# FORM FOR PROPOSAL FOR 2014 NATIONAL ELECTRICAL CODE®

1. Section/Paragraph FIG 690.1(A)

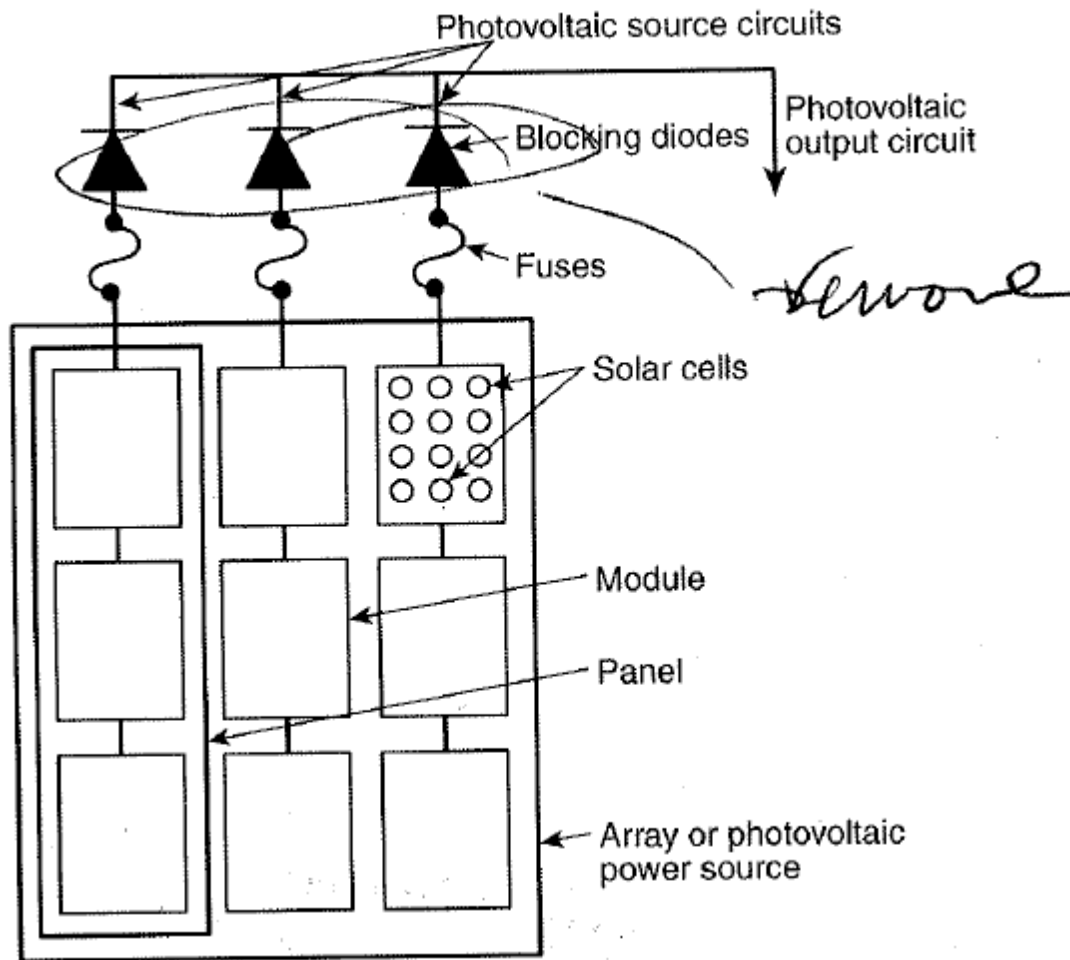
Remove the blocking diodes from the diagram as noted below

Some AHJ's view the blocking diodes as mandatory since this figure is not in an Annex or Informative Note as required by the NEC Style Manual for non mandatory material. Blocking diodes are no longer used in PV arrays and to keep them in the diagram may be confusing. They are a hold over from systems of the 1970s and 1980s before the NEC and UL standards required fuses to protect PV conductors and PV modules.
